**Review of
Murraylink Transmission Company Pty Ltd's
Application of the Regulatory Test**

**As provided to the
Australian Competition and Consumer Commission**

**Final Report
February 2003**

Figure 2.4 MW capacity of new generation plant commissioned under two bidding scenarios

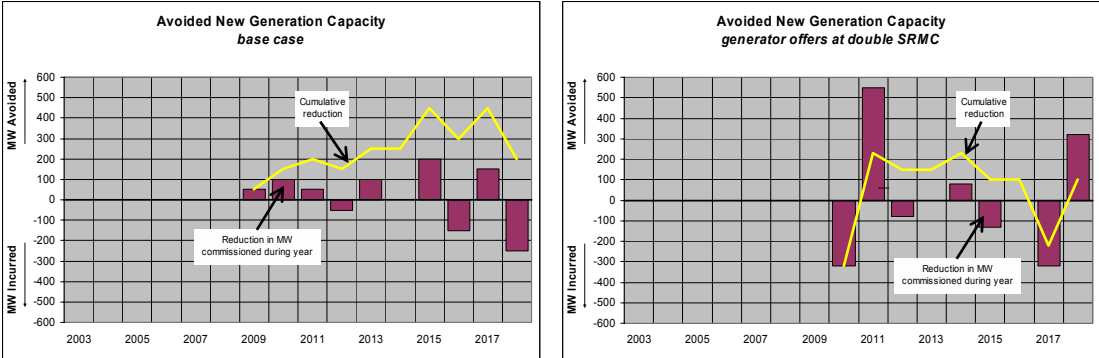
At SEIL's request, TEUS extended the base case economic growth scenario computations to 2018, and ran an alternative development scenario which evaluated the impact on commissioning schedules of generator offers that are twice their SRMCs. The chart to the left, below, suggests that in the base case, the modelling may not have reached long run equilibrium in 2012 when 150 MW of new generation had been deferred and that it is slightly more likely to have stabilised (if at all) at 300 MW in 2016. However, it appears unlikely that Murraylink could in fact permanently replace 300MW of generation capacity. The chart to the right suggests that with higher offer prices the generation deferral may possibly stabilise in the model at around 100 MW.

Another test for long run equilibrium is to continue extending the computations to include additional years until the 40 year market benefit calculations stabilise. As can be seen from the chart below, extending the last year of computations by up to 5 years beyond 2012 would have markedly increased the 40 year NPV. Only when the computations extend to 2018 in the base case does the market benefit drop back toward the value estimated when the computations were made out to 2012.

Figure 2.5 Impact of modelling NPV of Market Benefits

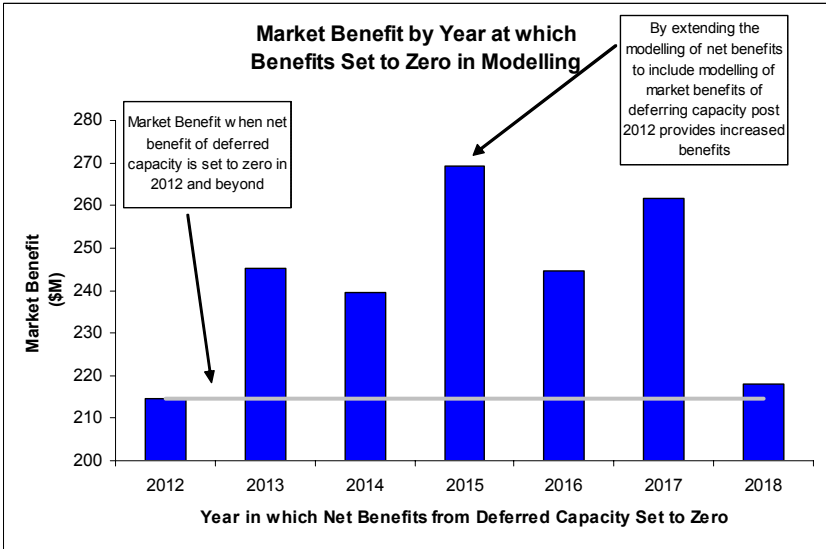
The chart indicates that TEUS has acted conservatively when it computed the results to 2012 and applied residual values beyond that date. However, we note that the sensitivity that the market benefit forecasts exhibit according to the manner in which the residuals have been calculated may have implications for consistency.

Figure 1 – Percentage share of annual benefit 2004-2013 and 2030 (from CRA report)

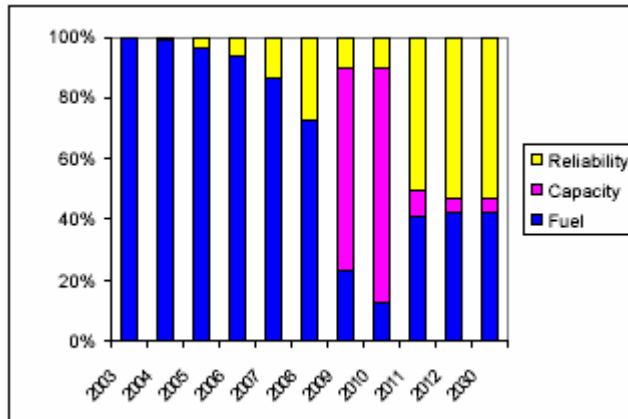
The chart depicts the percentage share of three components of the benefit—fuel cost savings, capacity deferral, and reliability—that have contributed to the market benefits in the base case economic growth scenario study. The chart does not incorporate the Riverland deferral benefits.

In this base case scenario, the generation capacity deferral benefits (merchant entry capital expenditure plus variable O&M savings and costs of voluntary load reduction) go negative in 2012. This is a result of Murraylink deferring the requirement for new generation from an earlier year. To prepare the chart (which would otherwise depict a negative percentage share) CRA has subtracted the \$26.7m merchant entry capital expenditure saving from the year 2011 and added it back to the 2012's loss. This process effectively sets the merchant entry capital expenditures for years 2011 and 2021 to zero.

performed for the year 2030. The share of benefits in that year, it says, match closely with those of 2011 and 2012, indicating that equilibrium was reached by 2012.

Figure 2 - Percentage share of annual benefit 2004-2018 (from TEUS extended computations)

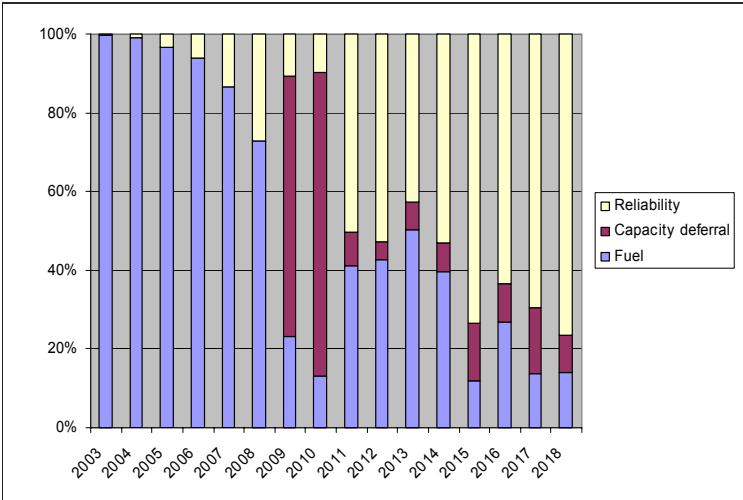
Since the Report was prepared, TEUS has prepared an unbroken sequence of annual runs that extend from 2003 through to 2018 (the “no black coal” variant). The ratios of fuel-cost-savings, reliability, and generation capacity deferral benefits (with the merchant entry capacity savings removed after 2010, as in the CRA analysis) are plotted in the chart below. This chart demonstrates that, with the sole exception of the years 2011 and 2012, there has actually been very little consistency in the ratios that CRA has studied.

We believe that this calls into doubt CRA’s conclusion that equilibrium is reached by 2012.
